# UPDATES NEEDED

Title modular8 prototyping system		
Size A	Number MOD8-002	Revision 0.1
Date:	8/14/2015	Sheet of
File:	C:\Users\...module_rev2.SchDoc	Drawn By: max.prokopenko@gmail.com

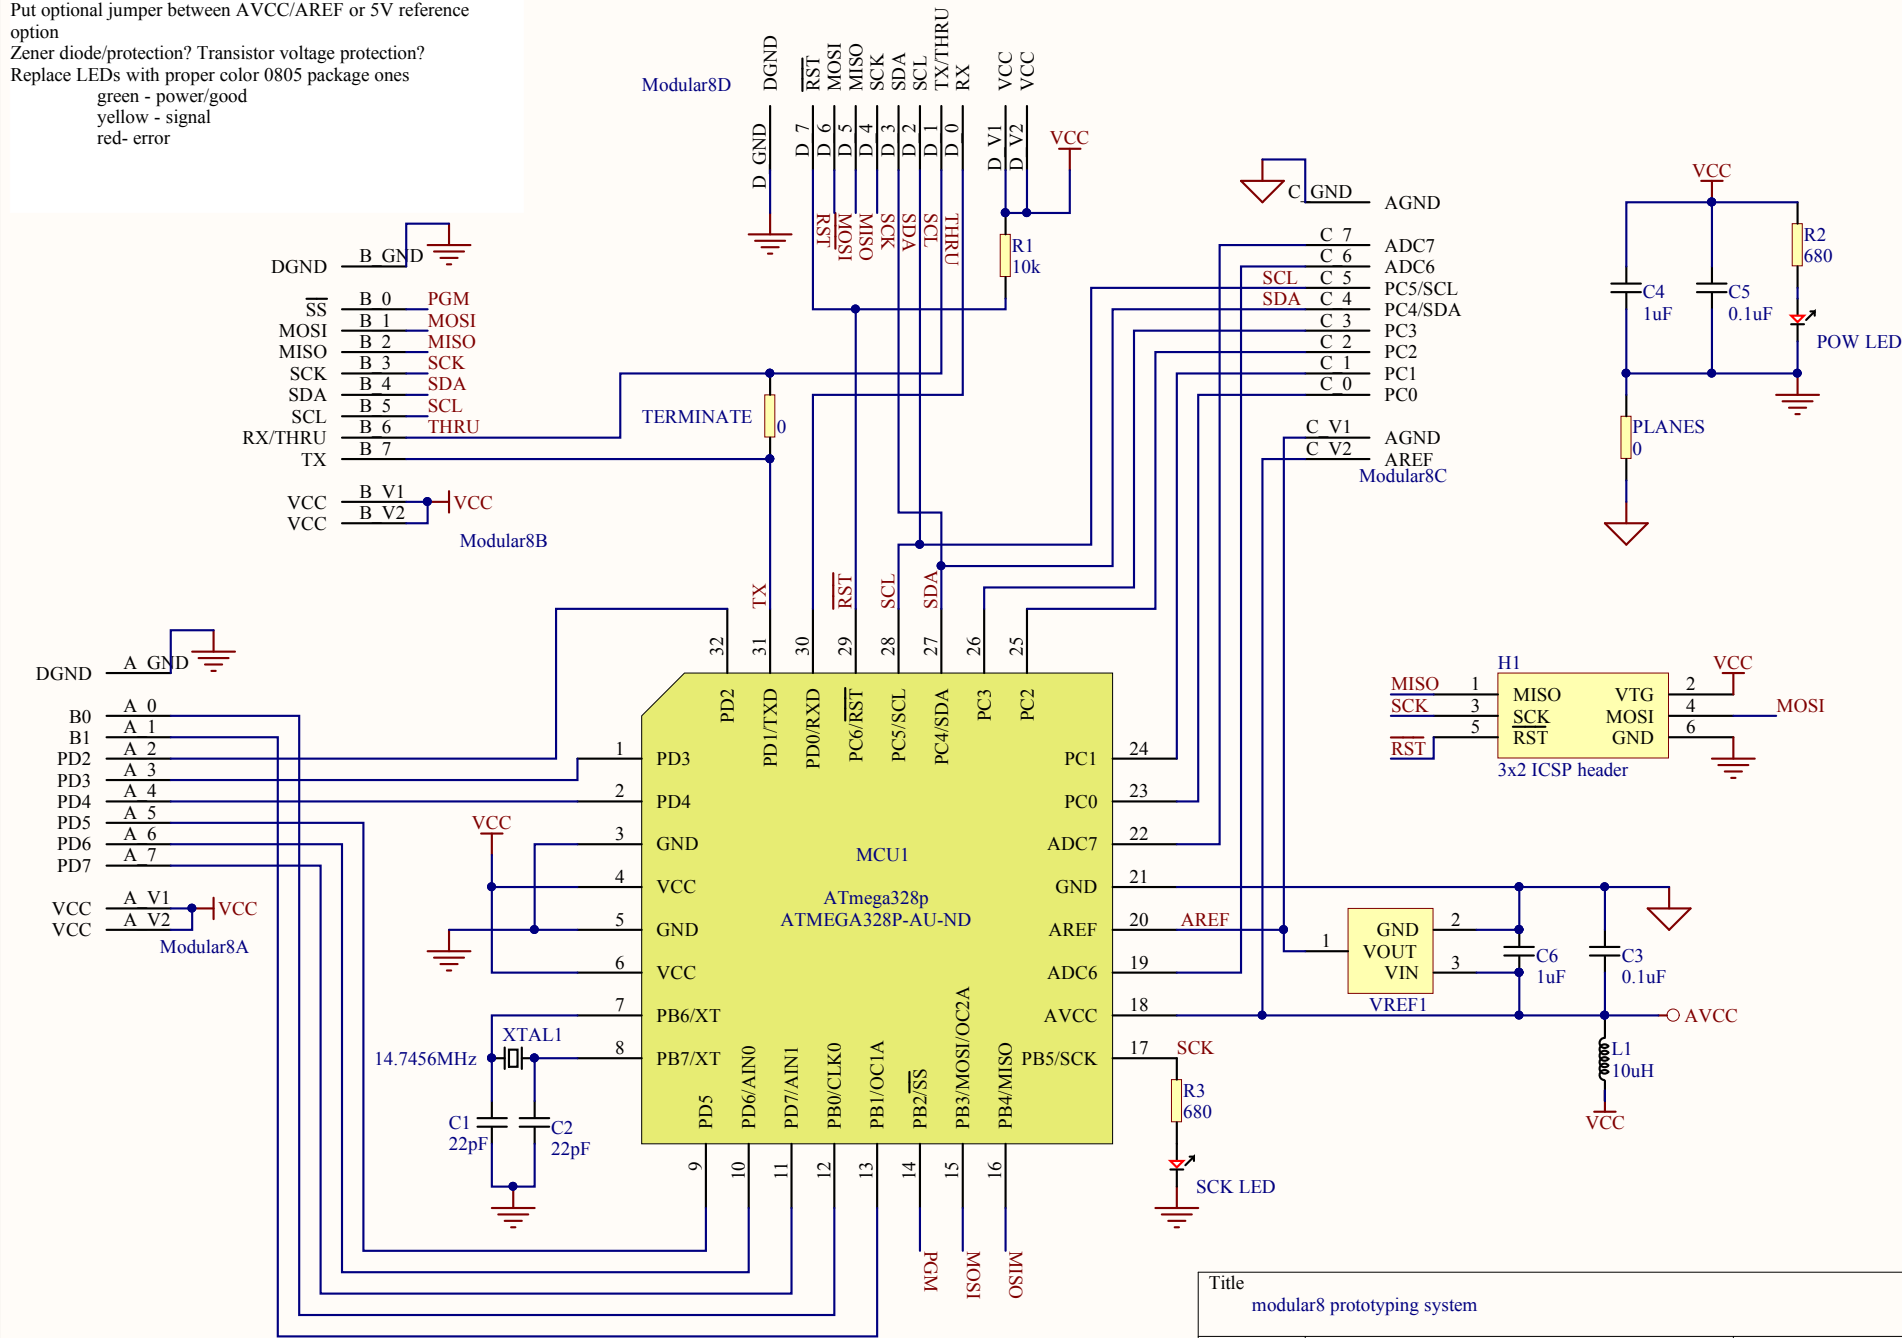
Put optional jumper between AVCC/AREF or 5V reference  
option  
Zener diode/protection? Transistor voltage protection?  
Replace LEDs with proper color 0805 package ones  
green - power/good  
yellow - signal  
red- error
